New Construction for:
Belmont College - Construction Trades Building

Addendum No. 06 – 21.162

January 27, 2025

BOLLARD LUMINAIRE BASE DETAIL

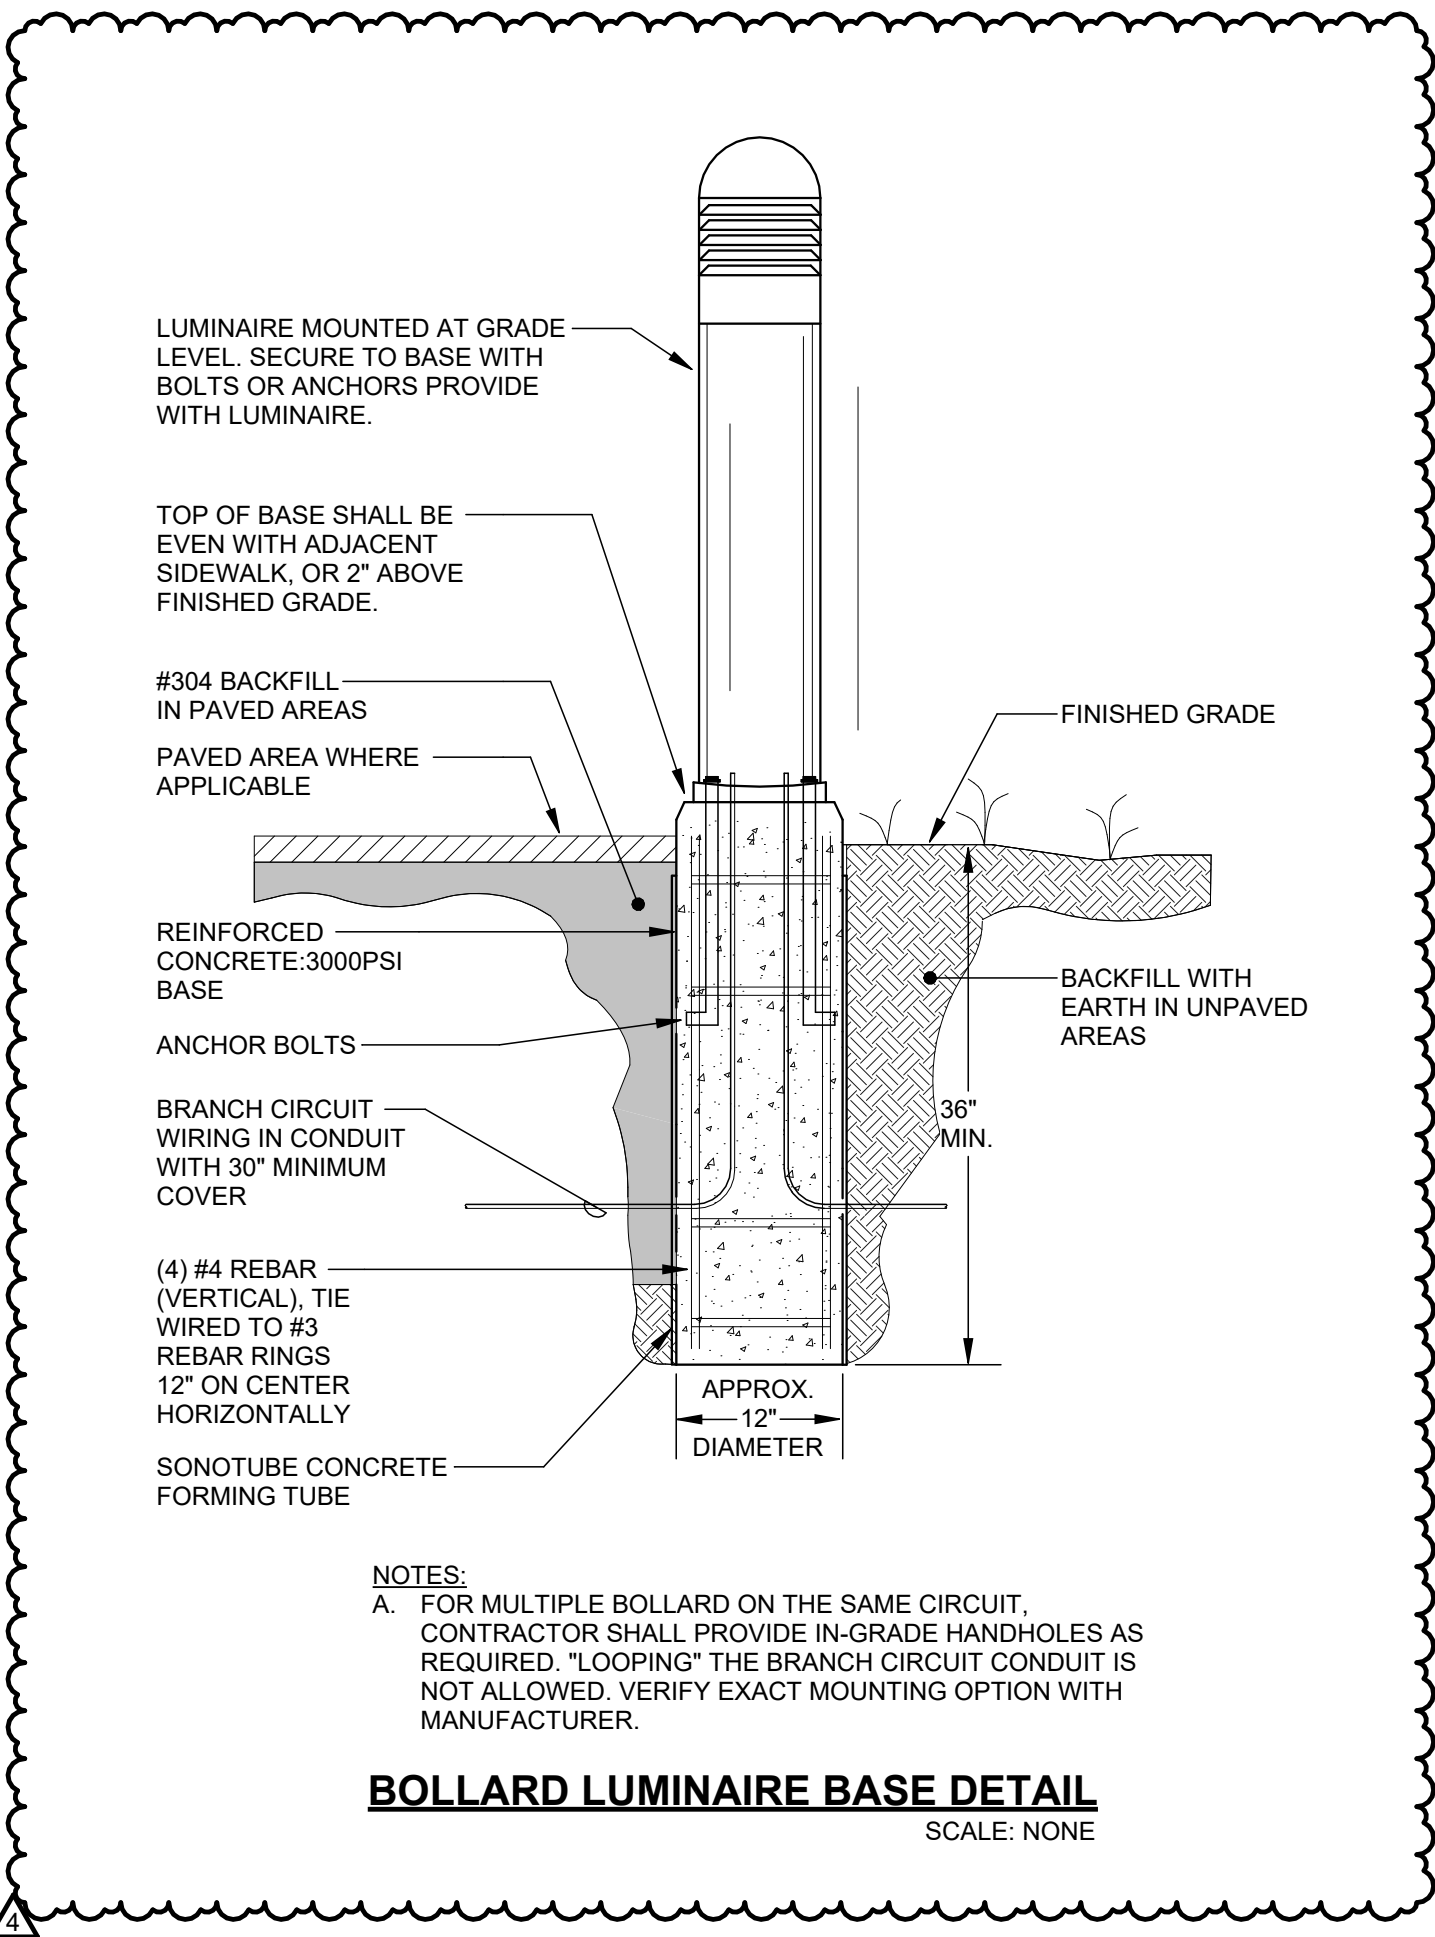
1. Question: Ref. Sheet E61. Please provide a foundation detail for Bollard Luminaire SB1.

1. Drawing E61 – ELECTRICAL DETAIL AND DIAGRAMS
 - A. Foundation details have been added.

Response: Foundation detail has now been provided.
